District Department of Transportation

Roadway Safety Audit Edgewood Road Washington, DC

DDOT Traffic Engineering and Safety Team

September 2, 2014

Figure 4 – Illegally Parked and Standing Vehicles on Bus Pad

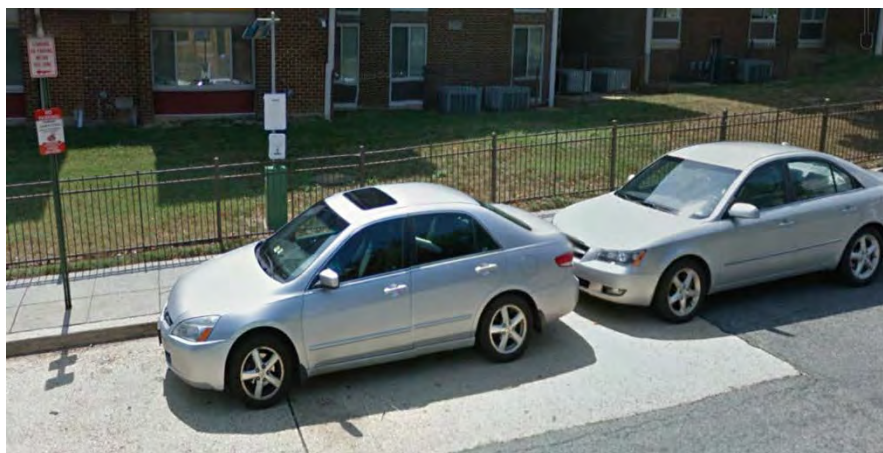
- There are parking restriction signs on Edgewood Street that prohibit parking in a bus zone. However, as shown in **Figure 4**, motorists were observed to parking and standing illegally in the bus zone. Further, the RSA team also observed parents illegally standing and parking their vehicles in the bus pad for drop-off purposes during the morning peak-hour. This creates direct conflicts between Metro bus operations and vehicles that are illegally parked and standing on the bus pad.

Figure 7 – School Bus in Wrong Lane

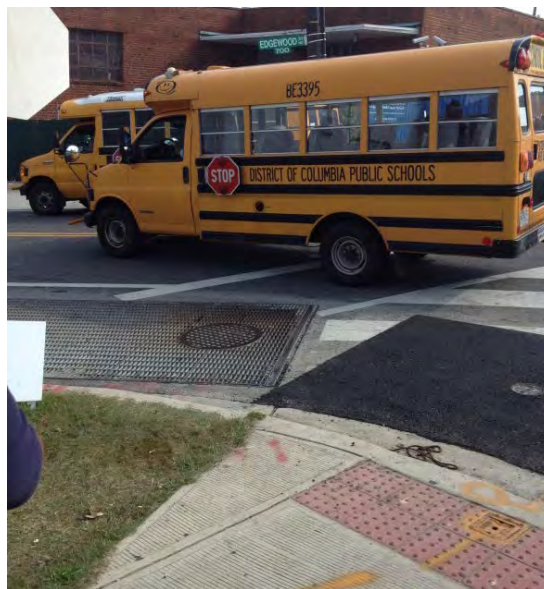
- The RSA team also observed a few motorists, especially school buses, traveling in the wrong travel lanes. This deliberate motorist behavior of driving in the wrong travel lanes, significantly increases the potential for head-on collisions, injury-related crashes and fatal crashes. **Figure 7** shows school buses traveling in the wrong travel lanes at this location.

Figure 9 – Obstruction at Pedestrian Ramp

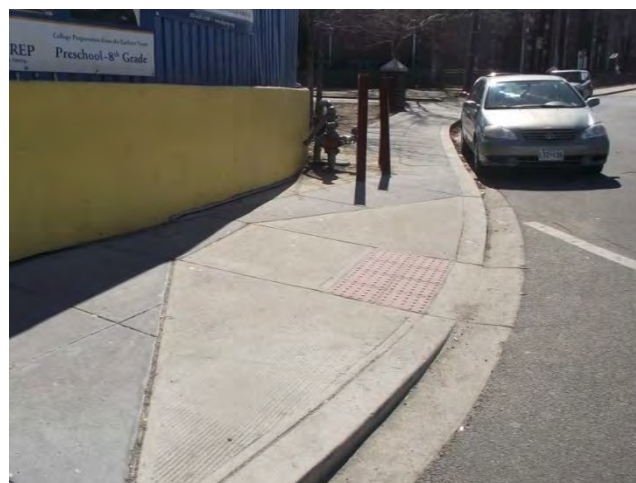
- The traffic control signs are either damaged or incorrectly mounted at this location (as shown in **Figure 8**). Further, there are no advance warning signs for the school zone installed at this location. The pavement markings for the existing crosswalk are faded and need to be replaced.
- The utility pole is installed very close to the pedestrian ramp, as shown in **Figure 9**. The utility poles obstruct access, especially for wheelchair users, to pedestrian facilities. It should also be noted that the sidewalk is very narrow at the terminus of the pedestrian ramp, and there is not enough turning space for wheelchair users to maneuver after leaving the crosswalk.

Figure 15 – Damaged Pedestrian Ramp

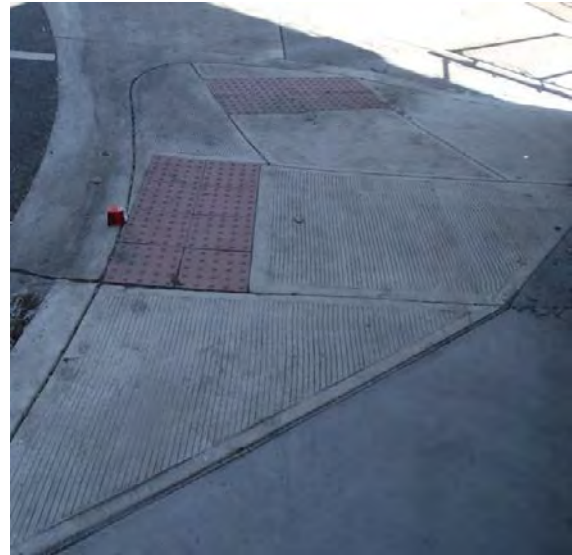
- Edgewood Street transitions to 8th Street, NE underneath the Franklin Street Overpass. There are two pedestrian crosswalks at this location. The pedestrian ramps at both crosswalks are non-standard and do not meet any ADA specifications.
- The landing areas at ramps are either missing or damaged. Further, the cross slopes are steep which create safety hazards for pedestrians, particularly wheelchair users. **Figure 14** and **Figure 15** show the non-standard and damaged ramps, respectively at this location.

Figure 17 School Valet Layout

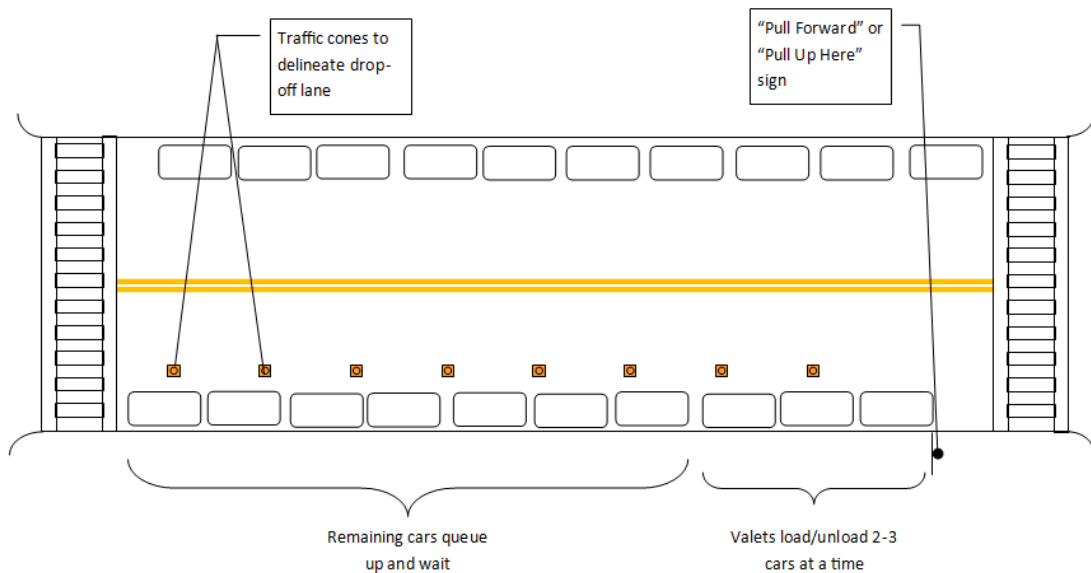
The study intersections along Edgewood Street, particularly the school access, experience significant vehicular congestion during the drop-off and pick-up sessions. Hence, the schools should implement a valet system in which school staff, parent volunteers and/or student safety patrols help students into and out of cars so that parents don't need to park their vehicles. School valet system would shorten the length of time that each individual vehicle spends at the school, and as such, would alleviate traffic congestion on Edgewood Street. Further, many schools in the District of Columbia have successfully implemented the School Valet programs. The following suggestions are recommended:

- Schools should identify specific areas for drop-off and pick-up and operate a valet system to help students into and out of the vehicles. One suggested location is Edgewood Street, between the school access and 8th Street, be designated as school valet for the drop-off and pick-up activities; for e.g. school valet area on Edgewood Street, between the school access and 8th Street, NE

- School staff or other volunteers should help students get safely into and out of the cars during drop-off and pick-up activities
- The school valet area should be delineated by using appropriate traffic signs and traffic control devices

- Schools should coordinate with MPD for enforcement and issuing warnings or tickets
- The school valet area should be delineated by using appropriate traffic signs and traffic control devices. Some schools put out cones to delineate the drop-off only lane as shown in the **Figure 17**. The cones are placed between the drop-off lane and the travel lane. The idea is that parents pull in at one end of the drop-off lane, and leave from the front. Parents are not allowed to enter or leave the drop-off lane anywhere in the middle and are instructed to stay close to the car in front of them. Putting a “Pull Forward” or “Pull Up Here” sign at the very front of the drop-off/pick-up area is also helpful to show parents where to stop. Position the valets near this location.
